Ichthystick II Electronic Fish Measuring Board Case
CABLE ASSY IFMB-10406

TITLE: WIRING DIAGRAM FOR
IchthystickII FMB Case

DWG NO. IFMB-10406

REV. A
12/11/2013

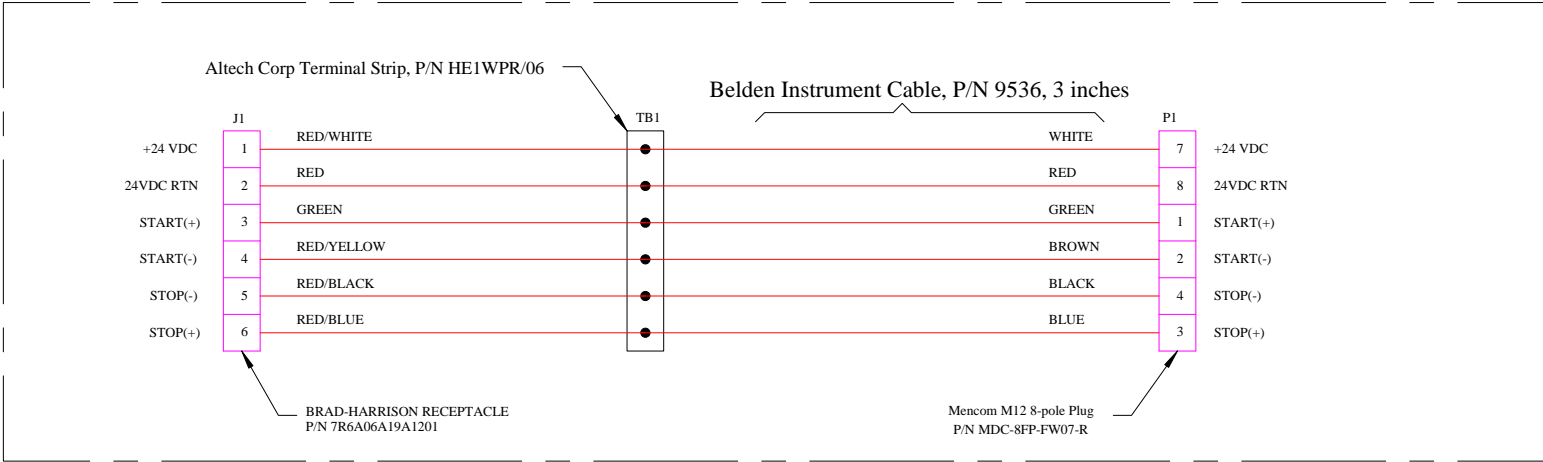
- Notes:
- 1. The new model EP2D (Generation 3) linear Sensor changed the output connector to an M12 (D84) male connector. Revision A of this drawing updates the mating connector to Mencom MDC-8FP-FW07-R connector which mates with the M12 (D84) receptacle on the linear sensor.
